WANL-TNR-042

# MODES OF FAILURE ANALYSIS SUMMARY NERVA B-2 REACTOR

Astronuclear Laboratory  
Westinghouse Electric Corporation

Figure 1

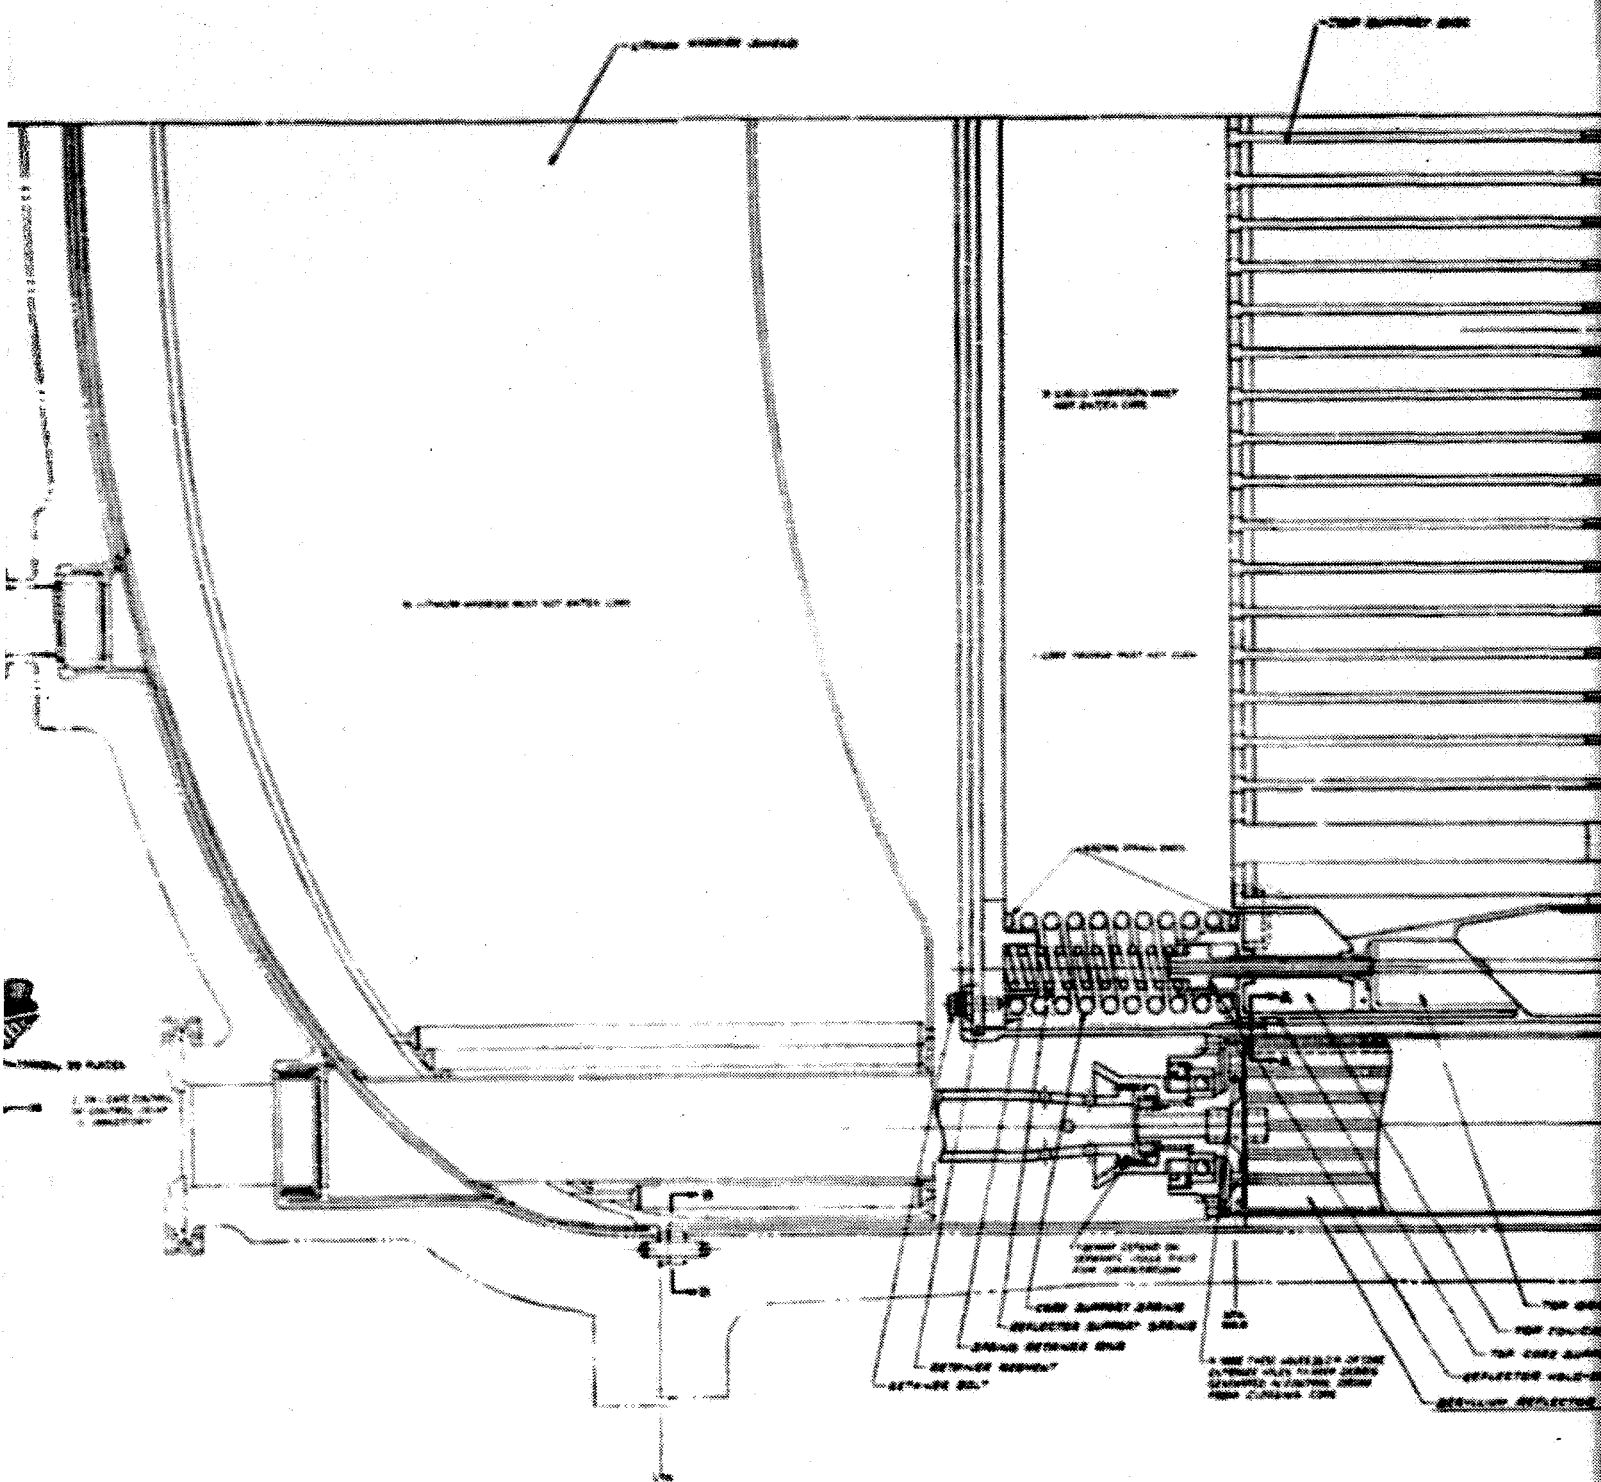
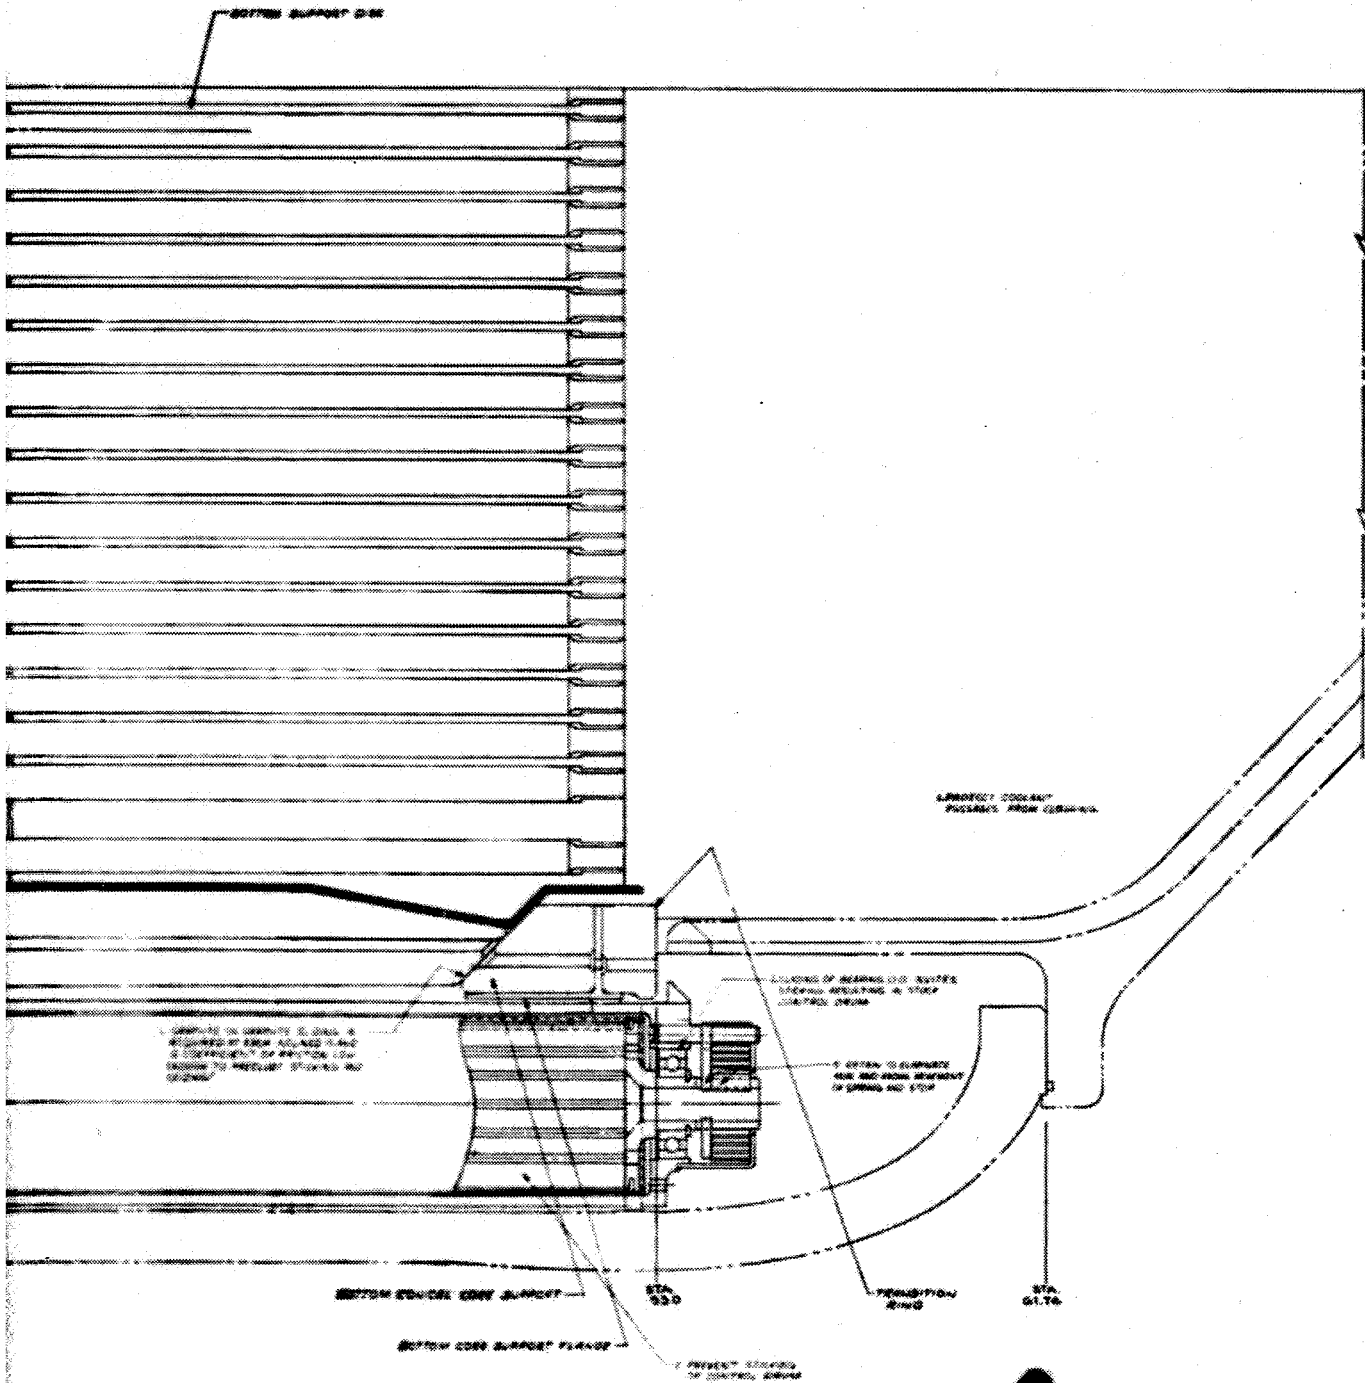
A. Suitable arrangements should be provided to prevent damage of the many cylinders due to relative rotation.

B. Radial expansion of the core when heated will cause axial gaps in the graphite reflector. That these gaps are not going to cause overheating of parts external to the graphite reflector should be determined. If the gaps are detrimental, these should be eliminated or the design modified to reduce the heat flow through the gaps.

C. Sliding of the bottom support plate on the inclined ramp may present some serious design problems. If the coefficient of friction of graphite on graphite is too high to permit sliding of the parts, the core support structure can be overstressed to the point of failure. Failure of the core support structure in this manner would result in a catastrophic failure of the reactor. The detail design of the core support, the top core support, and the reflector cylinder segments must consider the sliding of graphite on graphite; and design action must be taken to assure that seizure and sticking can never occur.

The bottom control drum bearing is designed such that the differential expansion is taken out by the outside diameter of the bearing sliding in the bearing holder. This is likely to promote sticking; thus, the control drum can stick and bind. The use of a roller bearing at this location would prevent this type of failure. In any case, a self aligning bearing should be used because of the distortion that takes place in the reflector assembly.

stop plate and spring have axial and radial freedom, being retained by a fixed cover welded to the bottom support ring. Vibration can cause wear and failure of these parts. Attachment of the stop plate and spring should be reviewed. It is suggested that these be individually attached, with all axial or radial play removed. Dependence on a welded-on sheet metal cover should be avoided.

depend upon separate loose piece. The design shown indicates a separate loose dowel pin in the connecting spline. The dowel pin can fall out at assembly, or can be left out. In either case the shaft may be assembled incorrectly. The results of such an assembly can be a nuclear accident.
